Customer: Haemonetics Penang		Date: 28-Nov-23	Time: 9:00
Participant From Maruwa		Participant From Organizer	
1. Mr Sasaki	CEO	1. Mr Allan	Plant Director
2. Mr Siva	Tool Manager	2. Mr Saw	Engineering Mgr
3.		3. Mr Chun Seng	Engineering
4.		4. Ms Wen Chee	Purchaser
5.		5. Ms Sim	Material Planner
		Report To	
		1. Datuk Anthony & Mr Sasaki	
		2. Mr Justin & Mr Prasan	
		3. Mr Naga & Mr Saupi	
		4. Mr Sathia & Ms Pang	
		5. Mr Mori & Mr Lai

SEAL ROTATING CERAMIC - UNGROUND CAUSE & ACTION

Process Flow (HAE IQC - Quality check) for Maruwa's Burr product (Uneven surface)

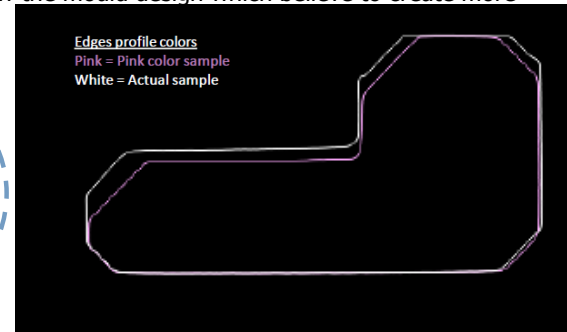
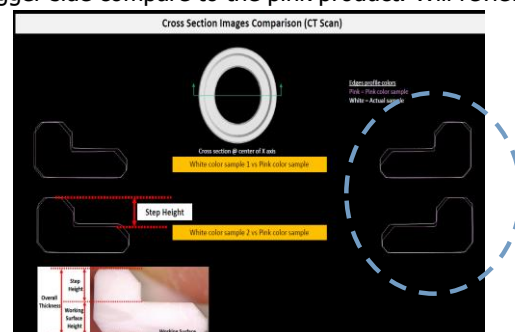
Effected Tool : D, E & H

- IQC - 100% Visual (100% Acceptance)
- After assembly - 30pcs bowl will be cut for cinform on
 - Crack
 - Carbon Inprint

All the cut bowl will be scrap

=> Maruwa: New spare tool expected incoming on 30th Nov => Effective 03rd Dec : Eliminate burr cutting process in Maruwa
